HISTORIC PRESERVATION BOARD STAFF REPORT

City Center (Doc's) - 10 N. Swinton Avenue

Meeting	File No.	Application Type
August 3, 2022	2022-060	CBD Waiver Request

The item before the Board is a recommendation to the City Commission for a CBD Waiver request associated with a Class V Site Plan and Certificate of Appropriateness to allow the use of the Porch frontage type instead of the required Storefront frontage type for a new 3-story structure for **City Center (Doc's), Old School Square Historic District**.

W. Atlantic Avenue Streetscape Section

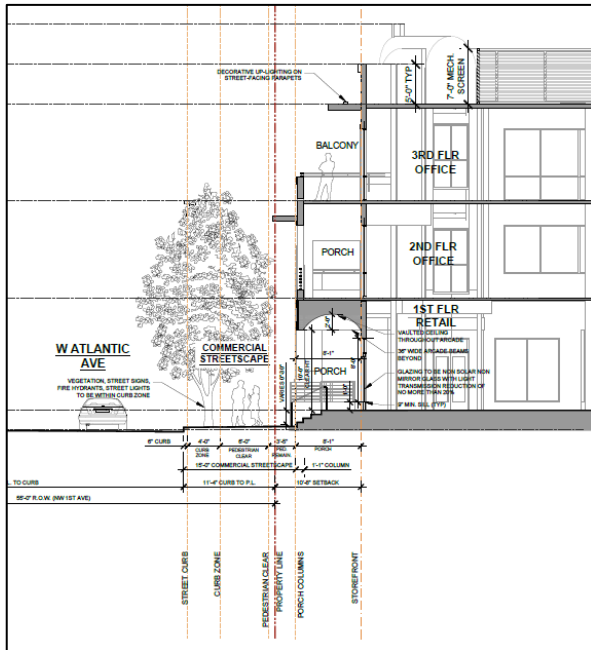
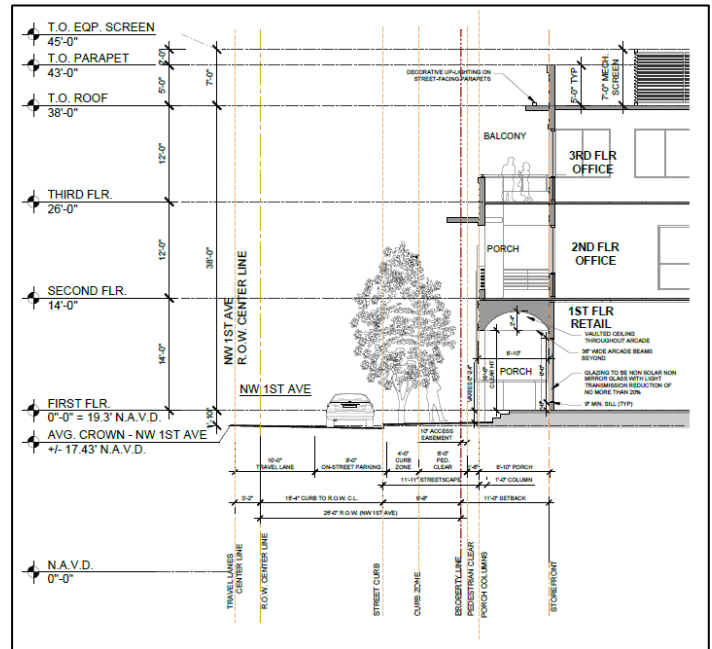
Diagrams provided demonstrate the porch does not encroach more than 8 feet into the minimum setback, as the building is setback more than the minimum of 0 feet, and that the minimum curb zone and pedestrian clear zone are met or exceeded, which are critical requirements that must be met in all instances of the proposed waiver. It is noted that architectural features in the diagrams below that extend into the public ROW must be removed and are not part of this consideration.

- A. Move to continue with direction
- B. Recommend approval to the City Commission of the Waiver request to use a Porch frontage type instead of a Storefront or Arcade frontage type, *provided the Porch encroaches no more than 8-feet into the minimum setback areas and the minimum curb zone and pedestrian clear zones are provided* for the property known as **City Center, Old School Square Historic District** by finding that the request and approval thereof is consistent with the Comprehensive Plan and meets the criteria set forth in the Land Development Regulations.
